Access Compliance Report

Public Rights-of-Way

(Curb Ramps)

Intersection ID: 12061	Main Street: TIPPAH_AV	Cross Street: CHAMBWOOD_DR	Location: SE
ADA ID: 01BA08FE80AF	Ramp Type: Perp	Initial Pass/Fail: Fail	Overall Compliance: No
Severity Score: 10			
Codes/Mitigation Info/Possible Solution		Field Measurements/Component Compliance

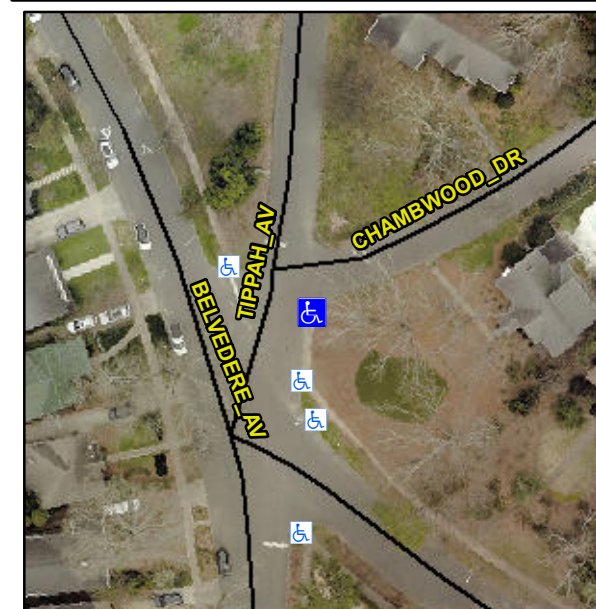
Not Found, R304.5.1

Compliance	Description	Data	Compliance	Description	Data
N/A	Ramp Length (in)	59.0	Yes	Ramp Slope (%)	7.4
No	Ramp Width (in)	47.0	Yes	Ramp XSlope (%)	4.3
N/A	Flare Type LT	N/A	N/A	Flare Type RT	N/A
N/A	Flare Slope LT (%)	N/A	N/A	Flare Slope RT (%)	N/A
N/A	Flare Traversable LT?	N/A	N/A	Flare Traversable RT?	N/A
N/A	Landing Length (in)	N/A	N/A	DWS Provided?	N/A
N/A	Landing Width (in)	N/A	N/A	DWS Contrast?	N/A
N/A	Landing Slope (%)	N/A	N/A	DWS Length (in)	N/A
N/A	Landing X Slope (%)	N/A	N/A	DWS Full Width?	N/A
N/A	Landing Curb? (Y/N)	N/A	N/A	DWS Offset (in)	N/A
N/A	Shared Landing?	N/A			
N/A	Gutter Ponding?	N/A	N/A	Gutter Slope (%)	N/A
N/A	Gutter Lip Ht (in)	N/A	N/A	Gutter X Slope (%)	N/A
N/A	Painted X Walk1?	No	N/A	Painted X Walk2?	N/A
	X Walk 1 Direction	To NW		X Walk 2 Direction	N/A
N/A	X Walk 1 Width (in)	N/A	N/A	X Walk 2 Width (in)	N/A
	X Walk 1 Slope (%)	4.4		X Walk 2 Slope (%)	N/A
	X Walk 1 X Slope (%)	6.6		X Walk 2 X Slope (%)	N/A

Remove & Replace Entire Ramp.
